Bernie Thompson & Roger Smith  
NRC Interviews of 1-22-79 & 1-23-79

SUBJECT: CFCO/MIDLAND PLANT - JOB 7220

**CONSUMERS POWER COMPANY**  
**MIDLAND PLANT UNITS 1 & 2**  
**FINAL SAFETY ANALYSIS REPORT**  
 Generalized Subsurface  
 Profile Section B  
 (SK-G-108, Rev 0)  
 FSAR Figure 2.5-21

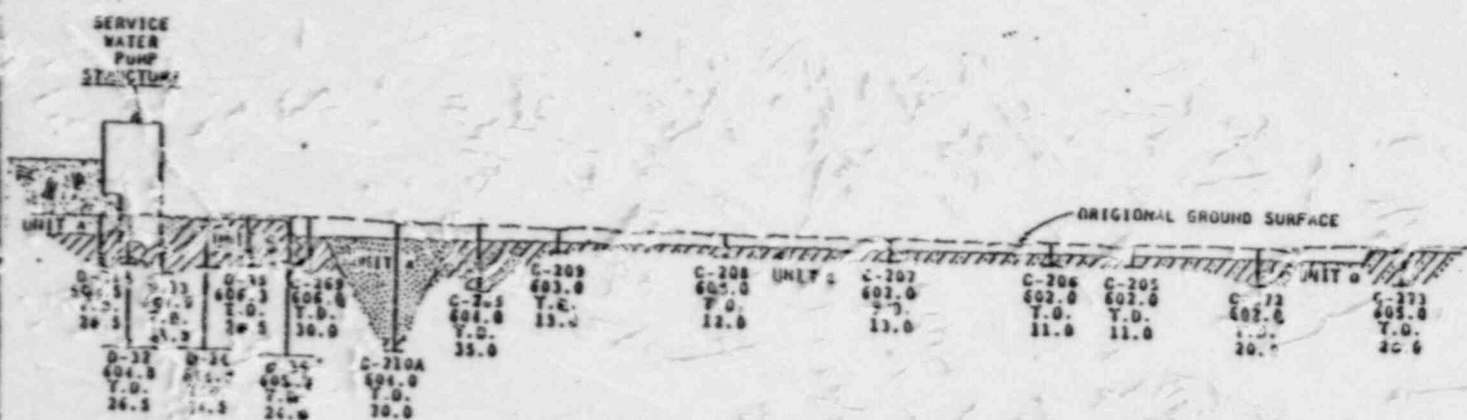
- a. This question concerns whether a natural sand layer near elevation 600', as identified in FSAR Figure 2.5-21, had been removed during construction or if the sand tested out to be greater than 75% relative density. The licensee had not responded to this question as of the date of this inspection.

FSAR Figure 2.5-47

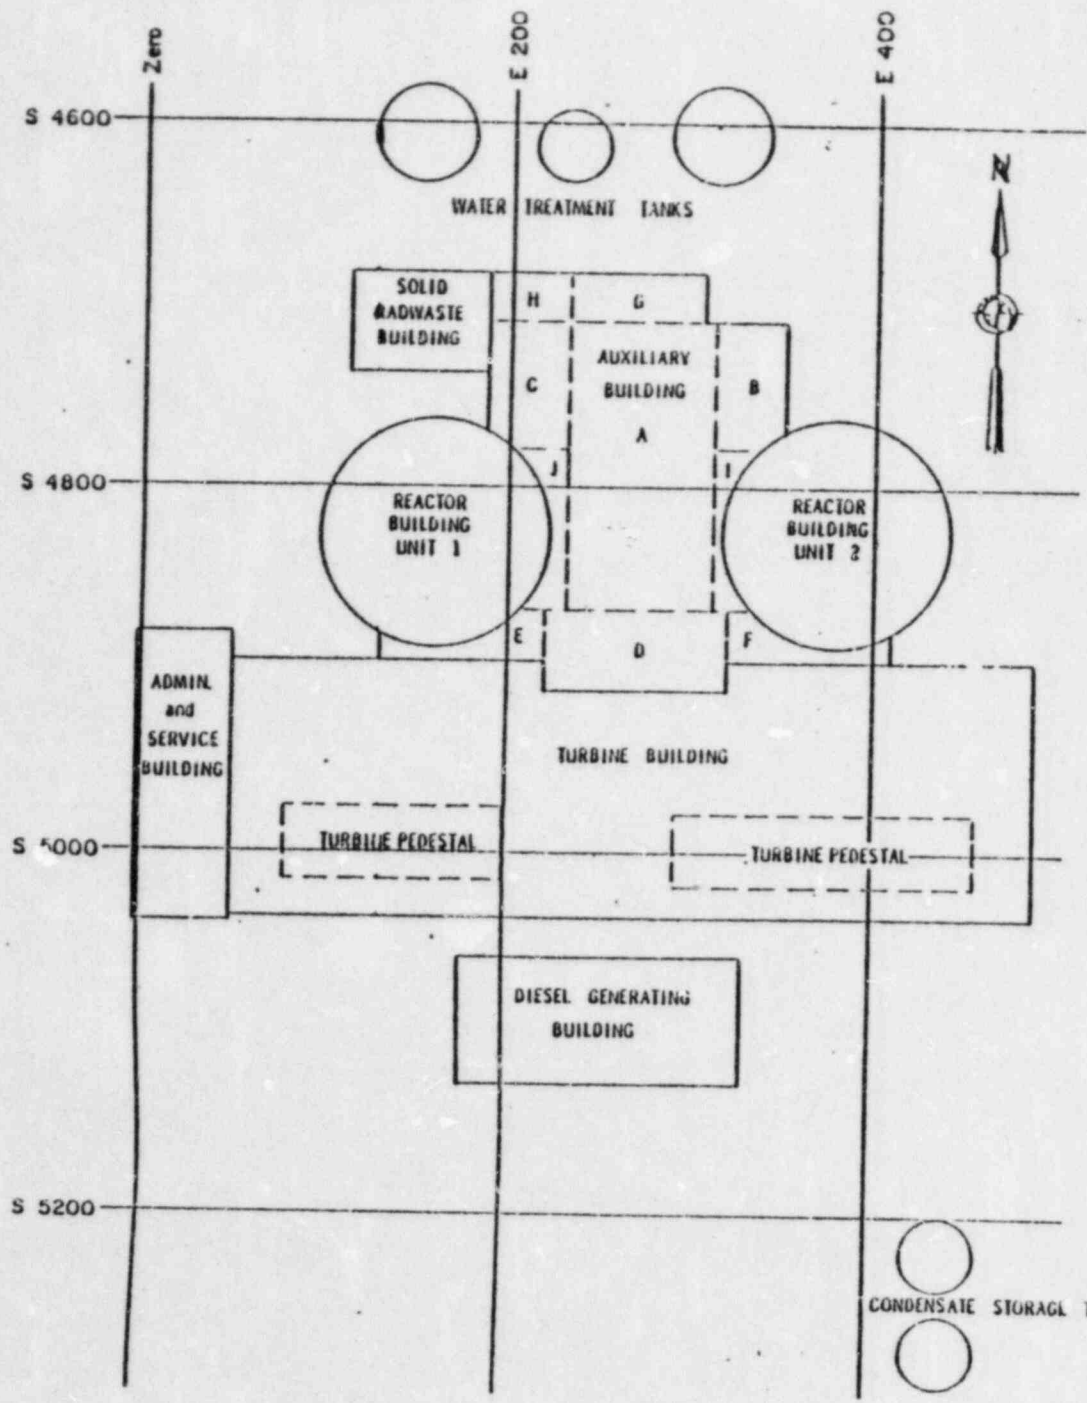
- e. FSAR Figure 2.5-47 indicates the foundation of the diesel generator building is at elevation 634'; however, design drawing C-1001(Q) R5 indicates the spread footing and pedestal are at elevation 628' and locally lowered to elevation 625' in the sump areas. Since the ground water elevation will be raised to 627', a hydrostatic pressure will reduce the net effective structure load on the foundation material. This should be reflected in table accompanying FSAR figure 2.5-47.

**CONSUMERS POWER COMPANY**  
**MIDLAND PLANT UNITS 1 & 2**  
**FINAL SAFETY ANALYSIS REPORT**  
Estimated Ultimate Settlements  
for Units 1 & 2  
(SK-G-55, Rev 0)  
FSAR Figure 2.5-48

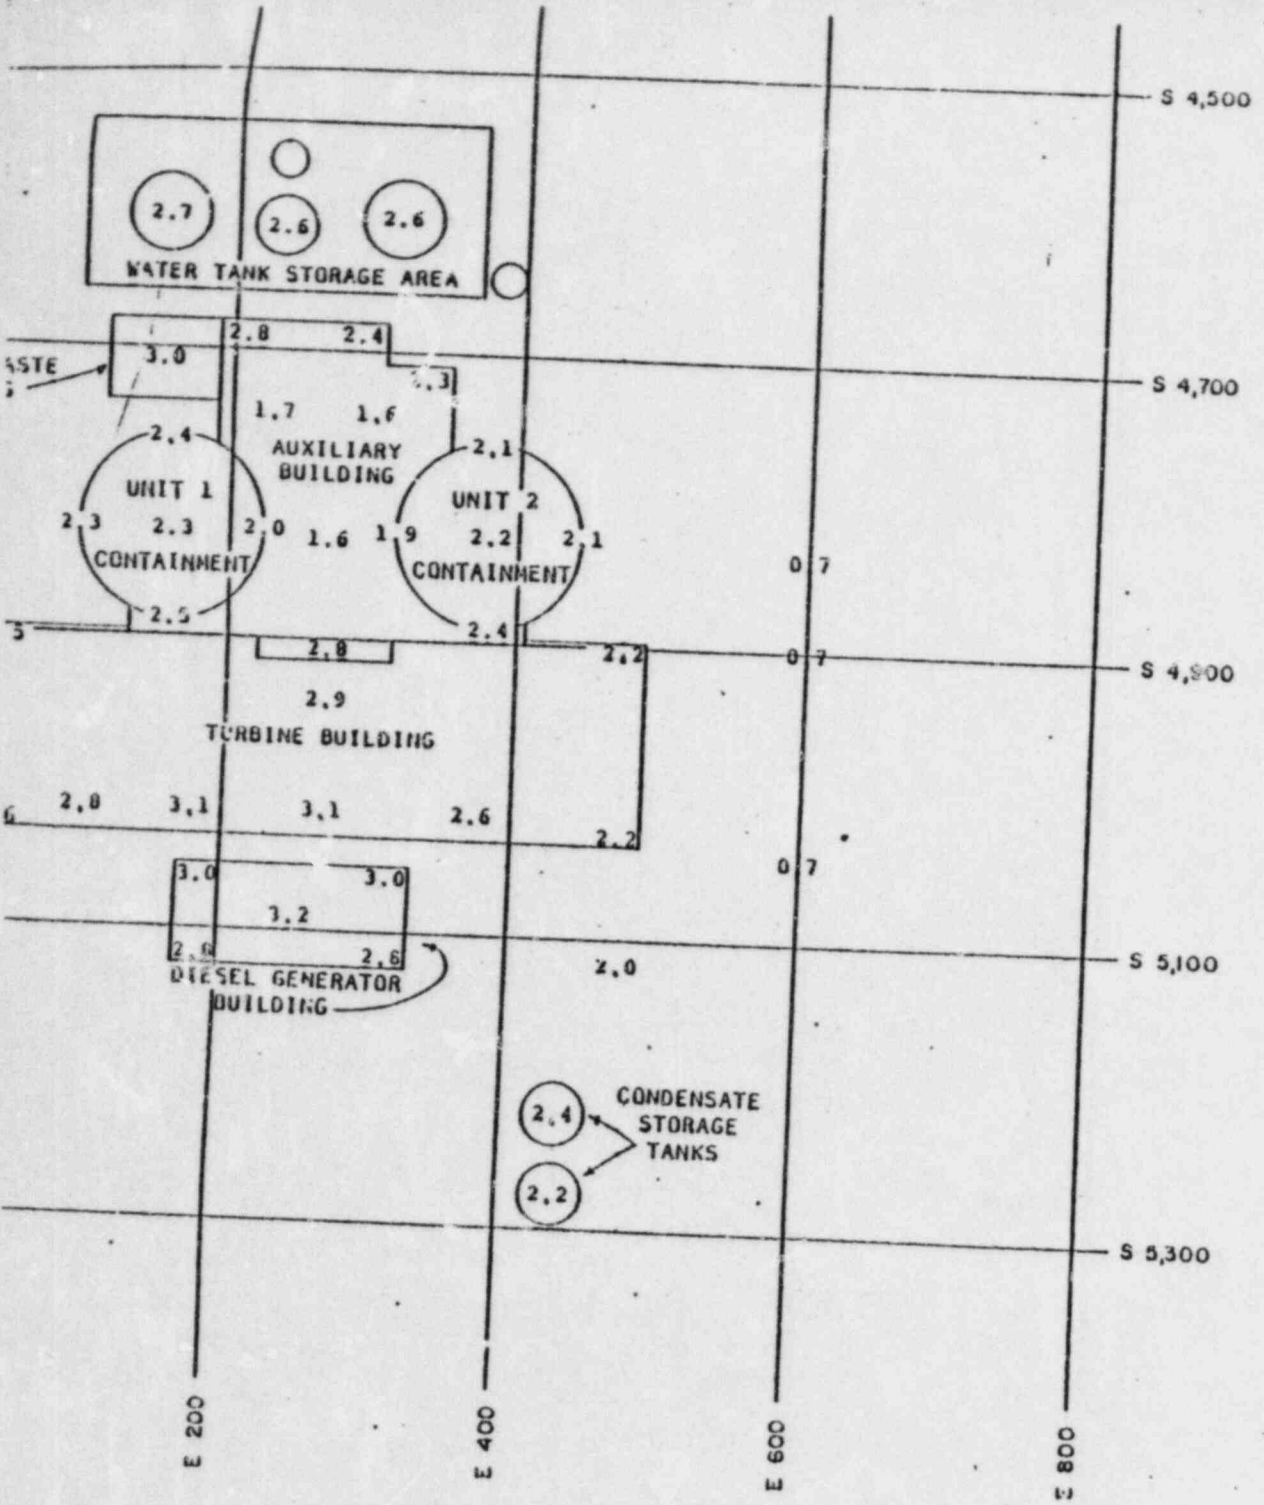
FSAR Figure 2.5 - 48 (See Appendix A) shows the estimated ultimate settlements for the DGB established on conventional footings over approximately 30 feet of controlled compacted granular fill. These estimated settlements are greater than those experienced to-date (See Appendix A - Figure 1, page 5, MCAR Interim Report 1).

Background was provided by P. K. Chen. It is necessary to confirm the settlement predictions presented in FSAR Figure 2.5-48 in light of the data obtained from the diesel generator building surcharge loading. Settlement parameters were back-calculated from the diesel generator building settlements measured during the pre-load program. Concern was expressed by K. Wiedner about the high settlement parameter back-calculated for el. 584-603 but Hendron said that this stratum has never been questioned before and is not of concern. P. K. Chen added that the layer is thin and the parameter will therefore have a negligible effect on the settlement. The settlement predictions were verified by (1) comparing soil parameters which were used previously to those which have been back-calculated and (2) by comparing the measured settlement for the reactor with the settlements calculated using the back-calculated parameters.
